SUPPLEMENTAL SHEET
CONTRACT CHANGE ORDER NO. 287
SHEET 2 OF 2

SAN FRANCISCO OAKLAND BAY BRIDGE
EAST SPAN SEISMIC SAFETY PROJECT

YBI TRANSITION STRUCTURES - HINGE K

HINGE KE & KW EXPANSION JOINT DETAILS NO. 2

ALTERNATIVE DETAIL A
1:2

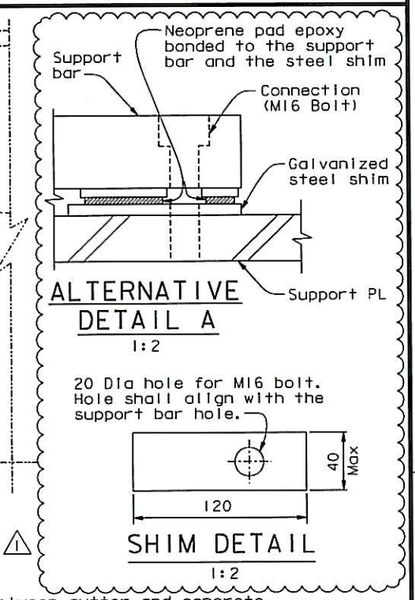
12. At the Contractor's option, Alternate Detail A may be used.
